Number	Description
1	Revised Table of Contents; Revised NTB 3052; SP 907-109-2 replaces SP 907-109-1; Revised Bid Items; Revised or Added Plan Sheet Nos. 8001-8002 & 8007; Amendment EBSx Download Required.

**SECTION 904 - NOTICE TO BIDDERS NO. 3052**

Bridge Preservation on US 80 over KCS Railroad (Bridge No. 107.8), known as Federal Aid Project No. NHPP-0472-00(019) / 108283301 in Newton County.

# ADDENDUM

**WORKING NUMBER**  
**1 OF 7**  
**SHEET NUMBER**  
**8002**

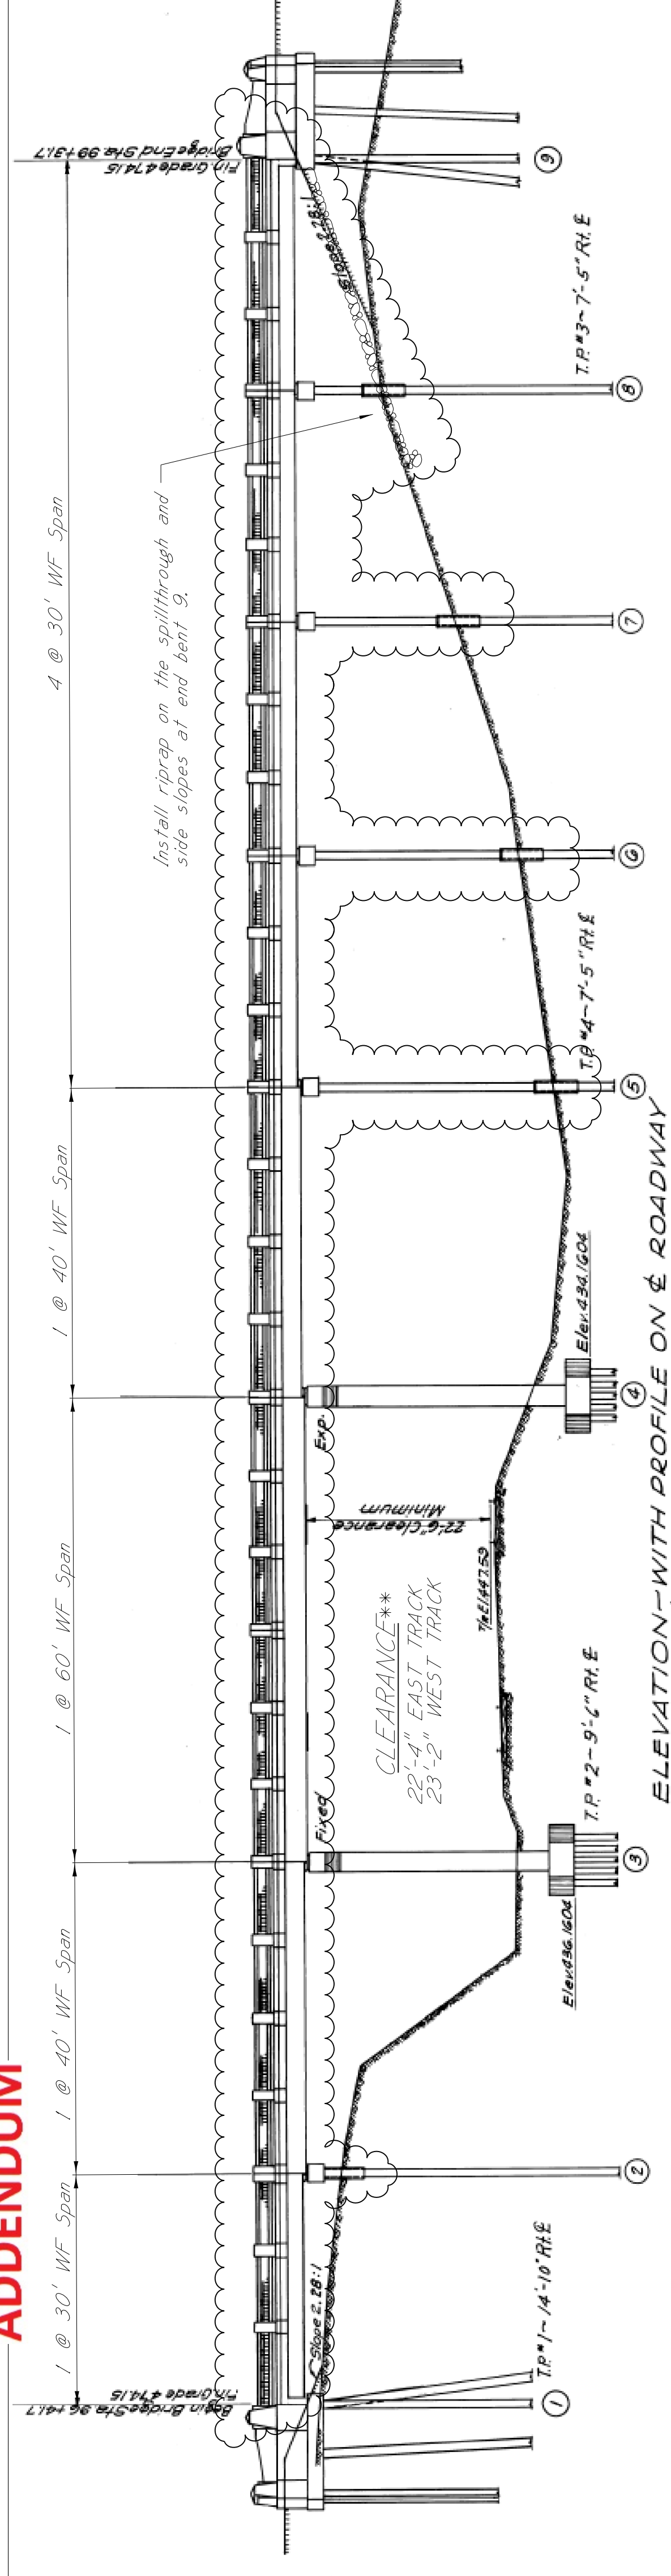
DATE	REVISION	BY
2/17/21	REVISED PAY ITEMS, SCOPE OF WORK	JDK
10/21/20	REVISED PAY ITEMS	JDK

WORKING NUMBER: 6 OF 7  
 SHEET NUMBER: 8007

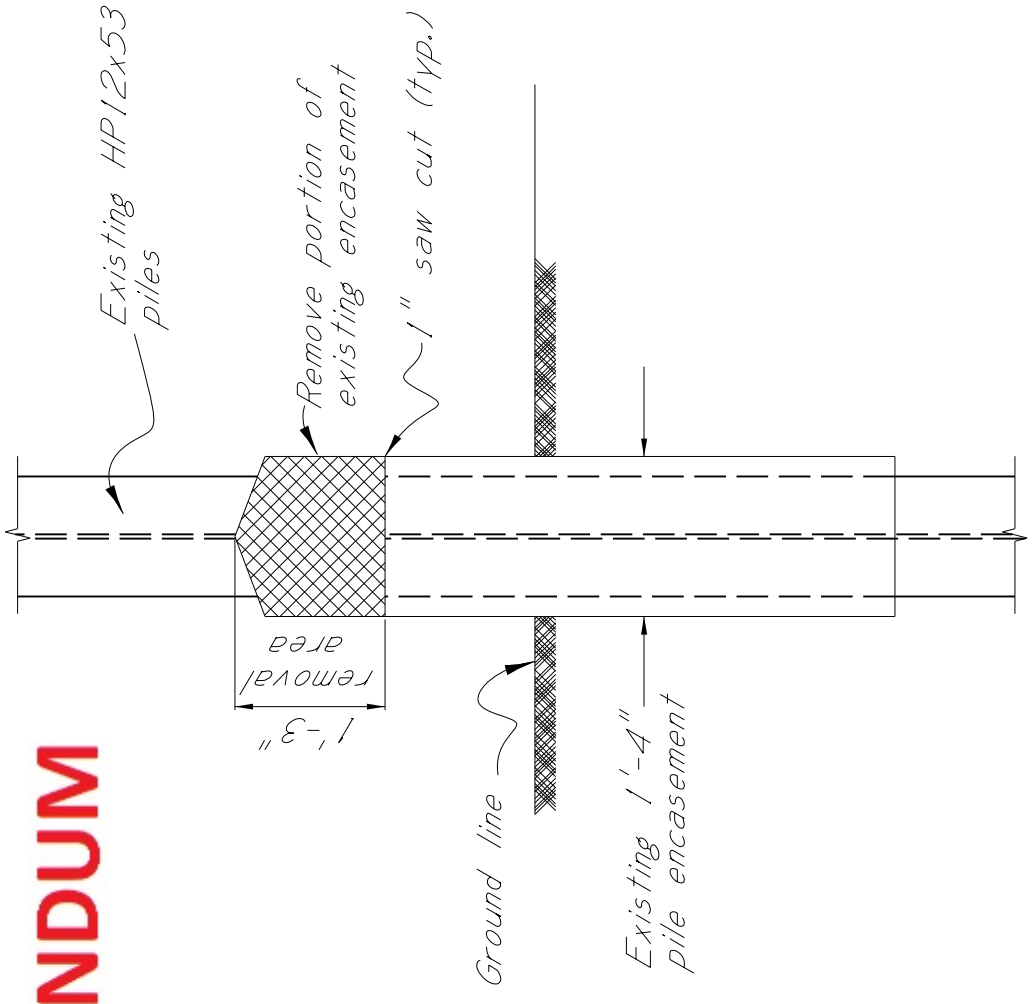
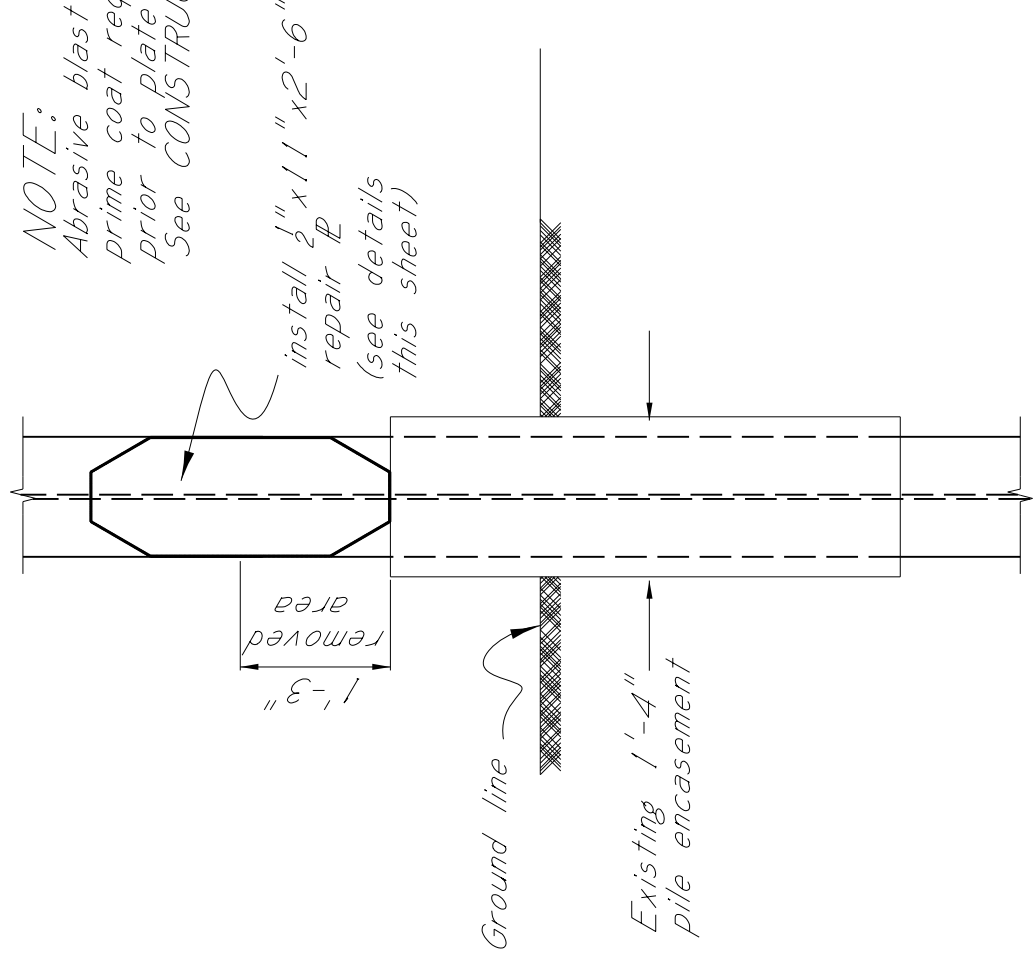
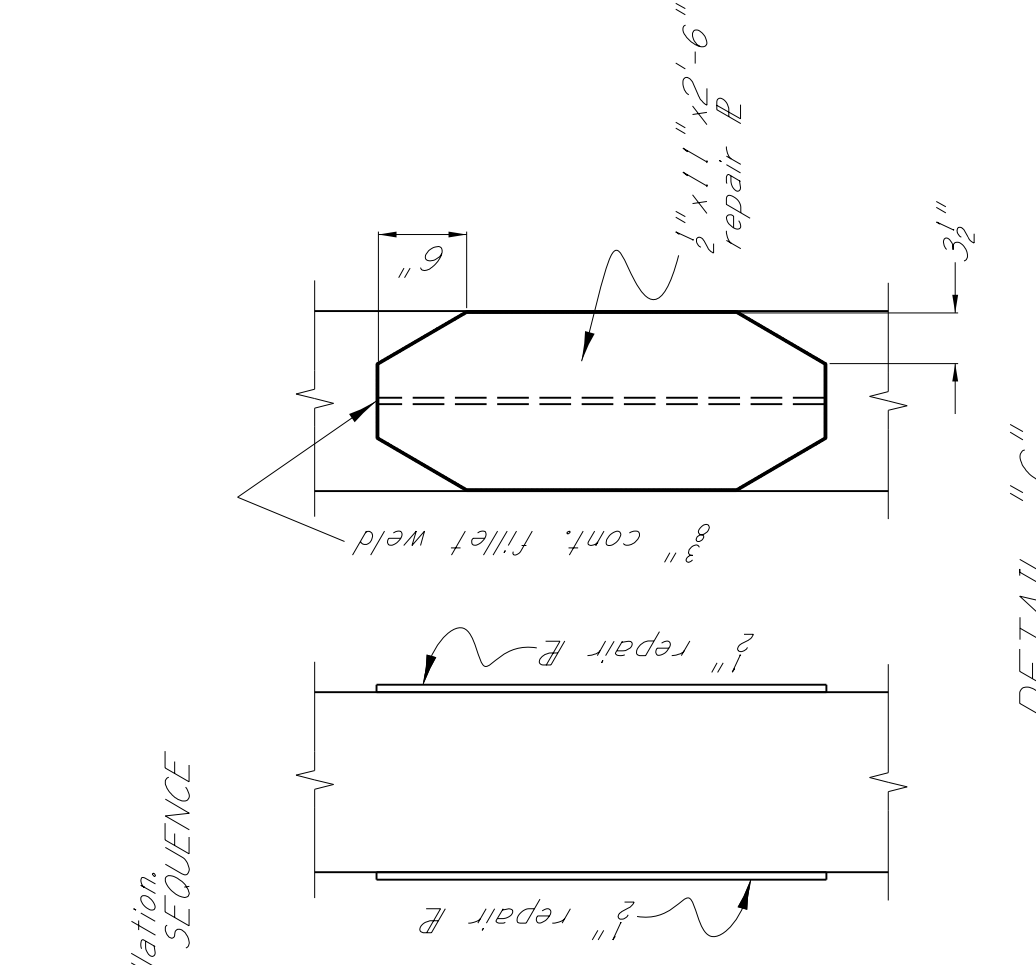
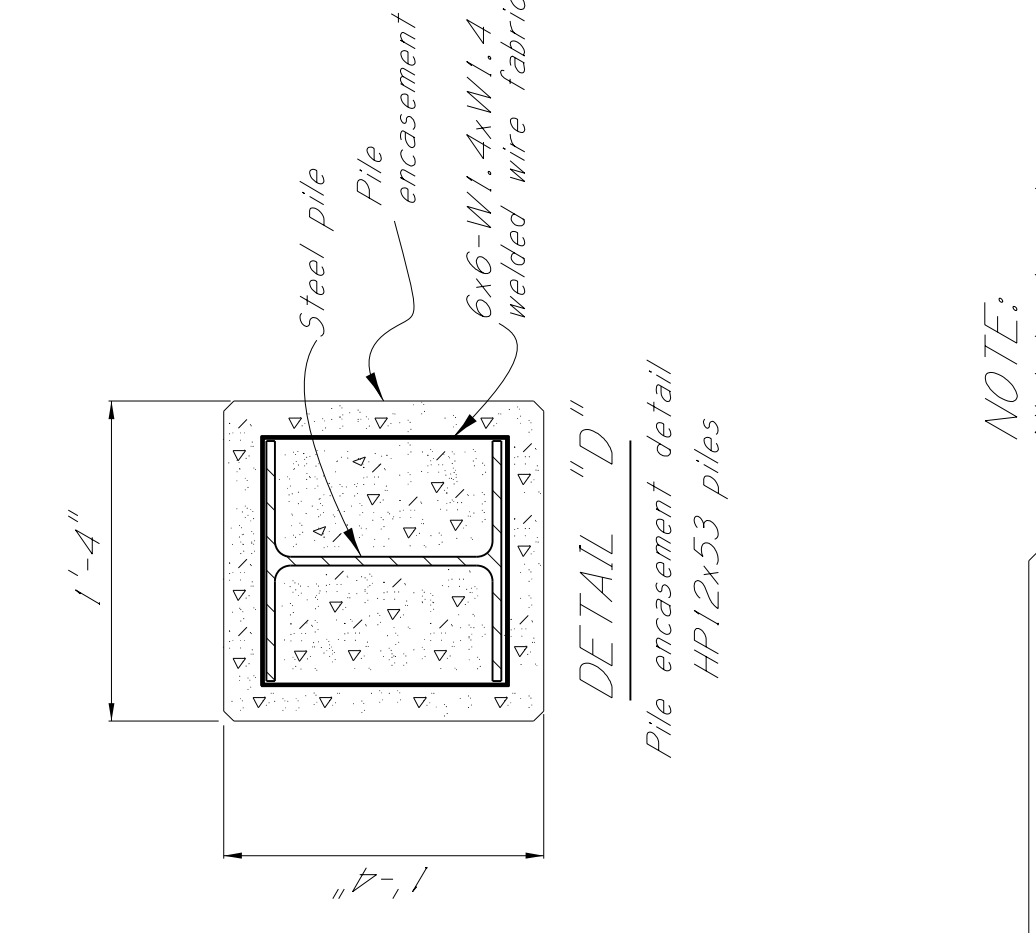
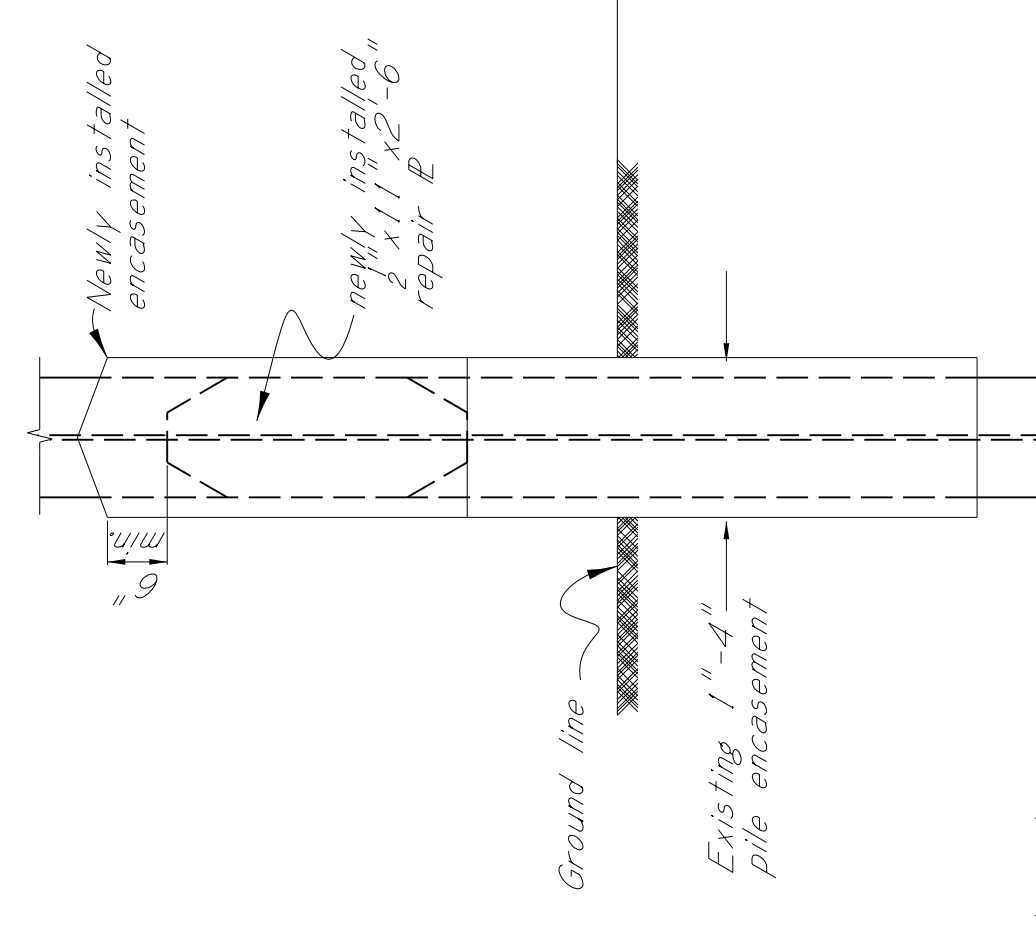
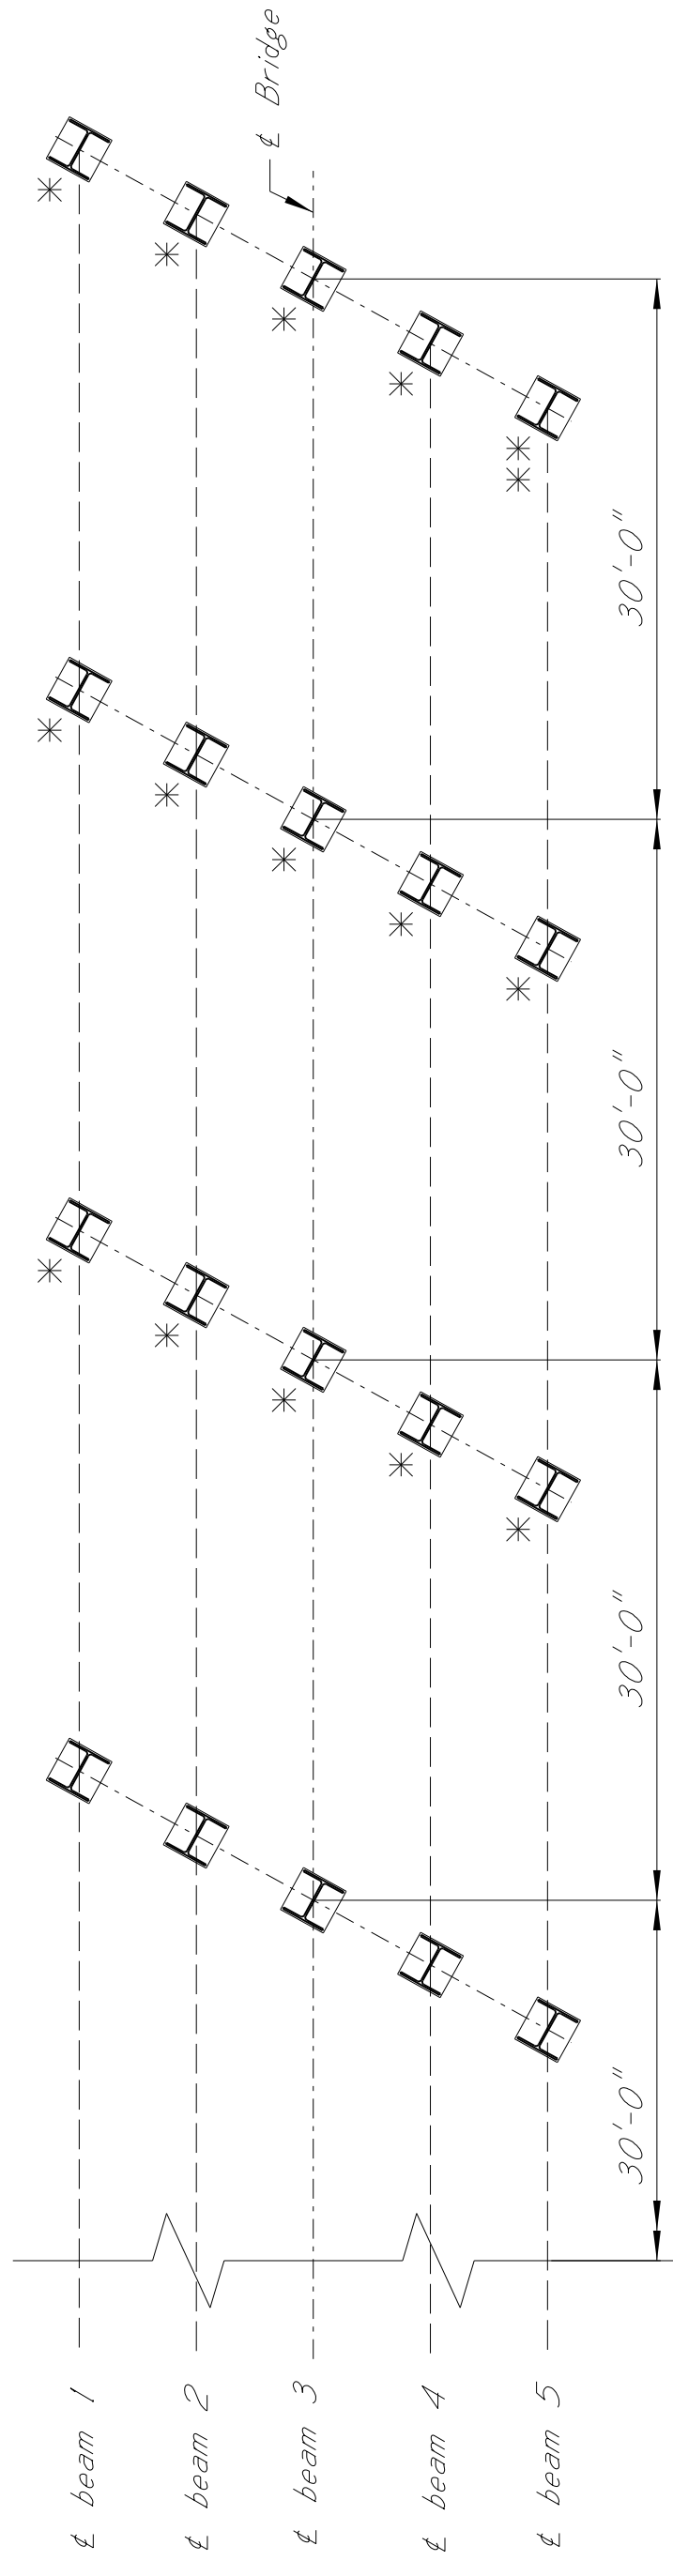
DATE	REVISION	BY	CHK
2/11/21	REMOVED TEXT
